Access Compliance Report Public Rights-of-Way (Curb Ramps)

Main Street: SNOW_BUSH_ST		Cross Street: CALLIANDRA_ST		Location:	E
ADA ID: RPRK211028135329	Ramp Type: Type 4 - Parallel	Initial Pass/Fail: Fail	Overall Compliance: No	Severity Score:	2
Codes/Mitigation Info/Possible Solution			Field Measurements/Component Compliance

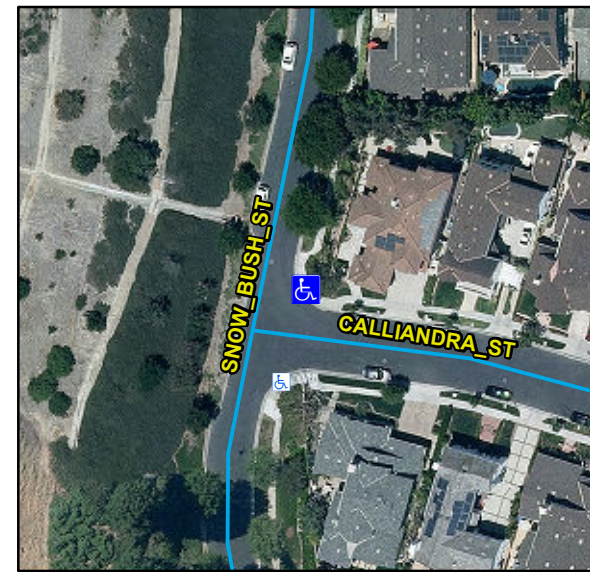
R204.3, R304.5.3, STD 1115

Remove & Replace Curb Ramp With Two New Directional Ramps or Equivalent.
